Lower Thames Crossing

9.214 Applicant's comments on Interested Parties' submissions at Deadline 8

Planning Inspectorate Scheme Ref: TR010032
Examination Document Ref: TR010032/EXAM/9.214

Document title	Interested Party (IP)	Link to IP's submission / Applicant's response
Specific Hearing 9		<p>Plate 1 Tree removal within Shorne/Brewers Woods east of The Nook Pet Hotel</p>

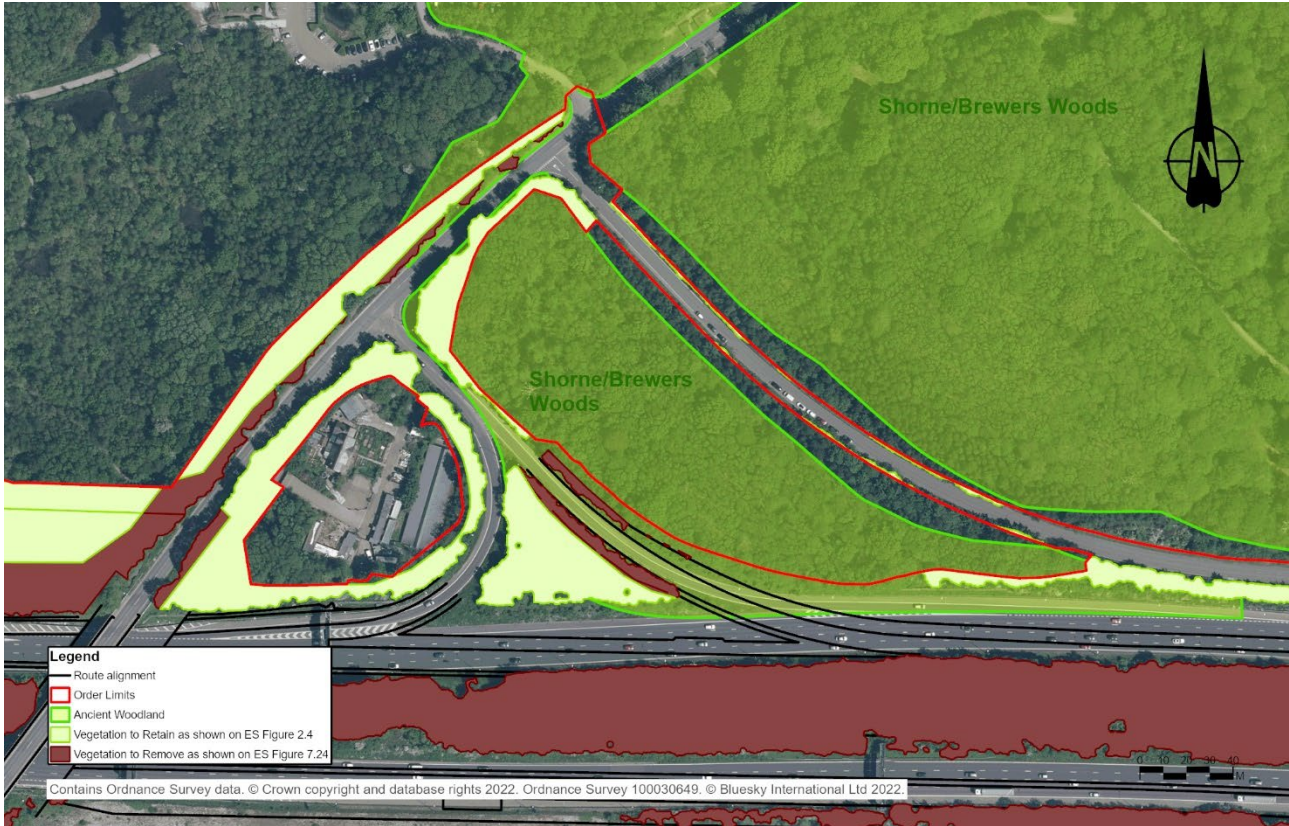
Document title	Interested Party (IP)	Link to IP's submission / Applicant's response
<p>Deadline 8 Submission - Comments on Applicant's submissions at Deadline 7 - 9.177</p> <p>Applicant's responses to Interested Parties' post-event submissions at Deadline 6 [REP7-188] in respect of Issue</p>	<p>Kent Downs AONB Unit</p>	<p>Link to IP's submission: [REP8-142]</p> <p>Applicant's response: In response to Kent Downs AONB Unit's concerns about the loss of ancient woodland east of The Nook Pet Hotel and the Applicant's assertion that '<i>only a small amount of woodland is currently shown as lost</i>', Plate 1 below has been compiled to show existing trees to be retained within ancient woodland (Shorne/Brewers Woods) to the east of The Nook Pet Hotel (pale green area in Plate 1 based on ES Figure 2.4: Environmental Masterplan Sections 1 and 1A (which have been updated for Deadline 9) [Document Reference 6.2 ES Figure 2.4 Sections 1 and 1 A 2.4 (4)]) and trees to be removed (brown area based on ES Figure 7.24: Tree Removal and Retention Plan [REP1-151]), overlaid on an aerial photograph.</p> <p>The extent of trees shown on ES Figures 2.4 and 7.24 (based on National Tree Map data, which records trees 3m and above in height) aligns with the existing tree canopies on the aerial photograph.</p>

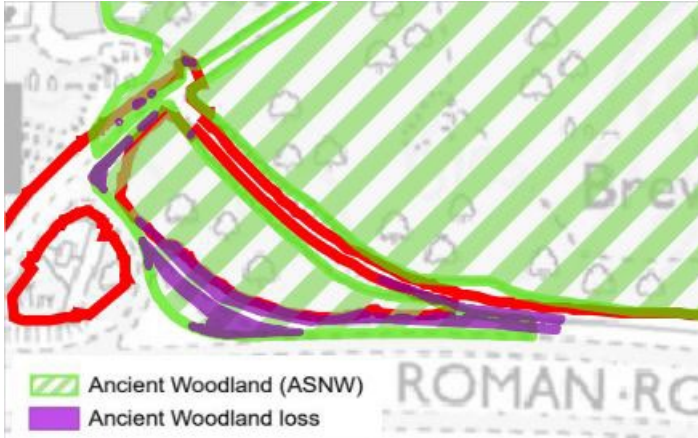
Document title	Interested Party (IP)	Link to IP's submission / Applicant's response
		<p>ES Figure 8.33: Ancient Woodland Impacts [APP-294] shows a precautionary assumption on ancient woodland impacts on the basis that all areas, other than those specifically identified for retention in the image above, would be lost as a result of the Project (refer to extract from ES Figure 8.33 in Plate 2 below, where the pale green hatch indicates the ancient woodland designation and the purple hatch indicates ancient woodland impacts). The Applicant also notes that the ancient woodland inventory mapping in this area extends across some hard surface areas of the A2 and the A2 slip road from Brewers Road.</p> <p>Plate 2 Extract from ES Figure 8.33: Ancient Woodland Impacts [APP-294]</p>

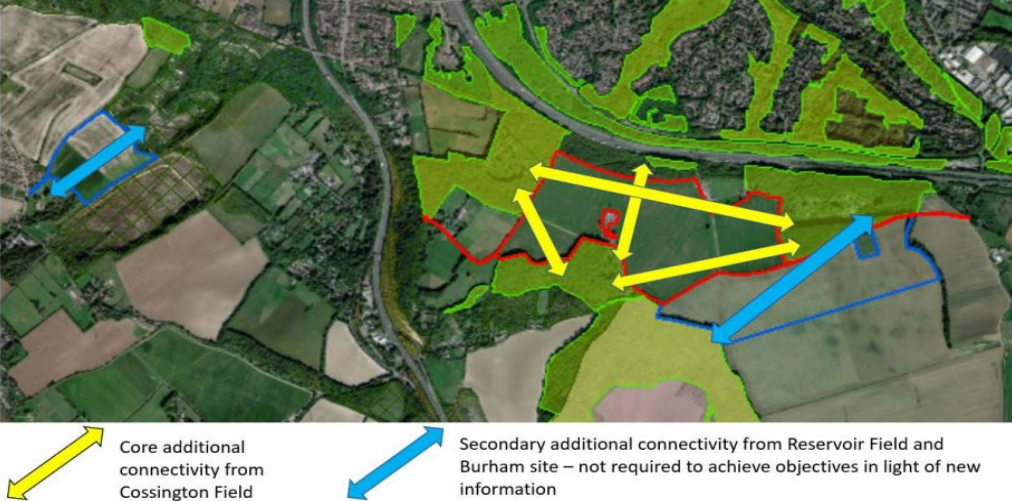
Document title	Interested Party (IP)	Link to IP's submission / Applicant's response
		<p>nitrogen deposition. This is in line with the Natural England's statement in their ISH 11 Action Point 17 response "...as we discussed and agreed with the Applicant during the preapplication period, we would expect at least the same area of habitat compensation being provided across the scheme to that being impacted." [REP8-154]</p> <p>In terms of how the removal of Reservoir Field and Burham affects the connectivity provided by the habitat created at Blue Bell Hill, Plate D.1 presented in Post-event submissions, including written submission of oral comments, for ISH6 [REP4-182], and reproduced below, illustrates how the removal of Reservoir Field and Burham does not significantly reduce the degree of connectivity the remaining habitat creation provides into adjacent habitat. Habitat creation at the Cossington Field site would provide new links into currently poorly connected woodland habitat to the north, south, east and west of that site, building resilience into the network of habitats which support the designated sites significantly affected in this area. Whilst the Burham site and Reservoir Field did provide secondary connectivity into adjacent habitats, the core connectivity is delivered through habitat creation at Cossington Field, and the removal of Burham and Reservoir Field does not weaken this provision. This reduction is therefore not considered to affect the robustness or proportionality of the overall compensation strategy. The Applicant welcomes Natural England's statement in their ISH 11 Action Point 17 response "<i>Based upon the compensation measures proposed by the Applicant and their location in Kent, Natural England advise that the measures are likely to be effective in building resilience around these sites.</i>" [REP8-154]</p>

Document title	Interested Party (IP)	Link to IP's submission / Applicant's response
		<p>Plate 3 Core and secondary additional connectivity at Blue Bell Hill (taken from Applicant's ISH6 Post-event submission [REP4-182])</p>  <p>Core additional connectivity from Cossington Field</p> <p>Secondary additional connectivity from Reservoir Field and Burham site – not required to achieve objectives in light of new information</p>
<p>Deadline 8 Submission - Annex 6 - Response to ExQ3</p>	<p>Natural England</p>	<p>Link to IP's submission: [REP8-155]</p> <p>Applicant's response:</p> <ul style="list-style-type: none"> • Q11.1.2 HS1 mitigation planting – The Applicant has provided a response to this matter in Responses to the Examining Authority's Third Written Questions (ExQ3) [REP8-115]. The Applicant considers that its assessment fully addresses impacts to and mitigation/compensation for third party projects. • Q11.1.4 Wildlife ponds for non-GCN – The Applicant considers the provisions of the Design Principles [Document Reference 7.5 (7)] and outline Landscape and Ecology Management Plan [Document Reference 6.7 (7)] allow for the consideration of factors proposed by Natural England as part of the detailed design process.
